SUBJECT: AOS RESPONSE TO NRC QUESTIONS (DATED 01-15-2019) TO
SUPPORT THE RESPONSE TO THE REQUEST FOR ADDITIONAL
INFORMATION ISSUED OCTOBER 9, 2018

USNRC Reference(s): Docket No. 71-9316
EPID-L-2018-LLA-0201

AOS Reference: FM9006.1-012019-001 and FM9006.1-1012019-002

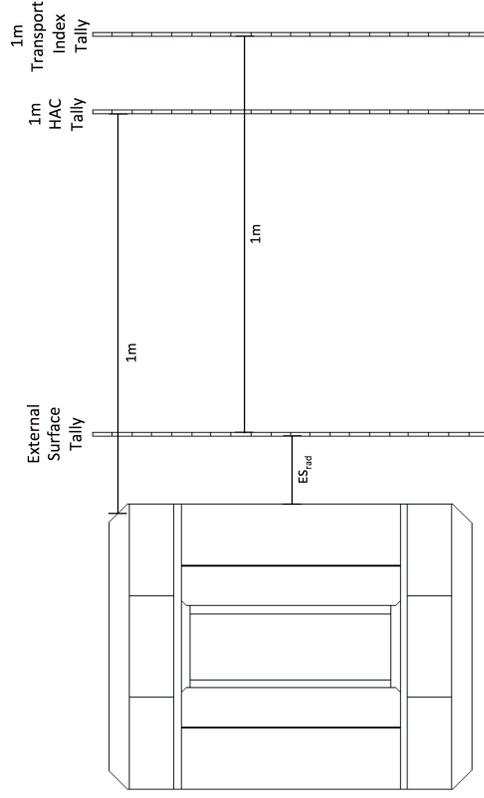
C.2. Confirm that the new Co-60-C TI dose rate/curie value was determined by calculation with MCNP. It is not clear that is so, but it should have been calculated in that manner. Note that it is still not clear to the staff that a factor of safety of 1 for the TI is sufficient. However, given the margin to the TI limit for the new Curie limit for the Co-60-C source and that no other TI factors for the other nuclides and package models in Appendix 5.5.8.1 were less than 2, there is enough margin to address the staffs concern and compensate for it.

Response: All dose rates are calculated using MCNP. The TI dose rate locations in the body of the calculation are at a distance of 1-meter from the deformed impact limiter surface, but the HAC dose rate locations are 1-meter from the cask surface itself, as shown in the image below (reference SAR Page 5-13) (SAR Figure 5-6, for a point source on the cask side wall). Because of this, the DR/Ci value calculated from the 1m HAC Tally location is used, as this is the appropriate distance from the exposed cask surface.
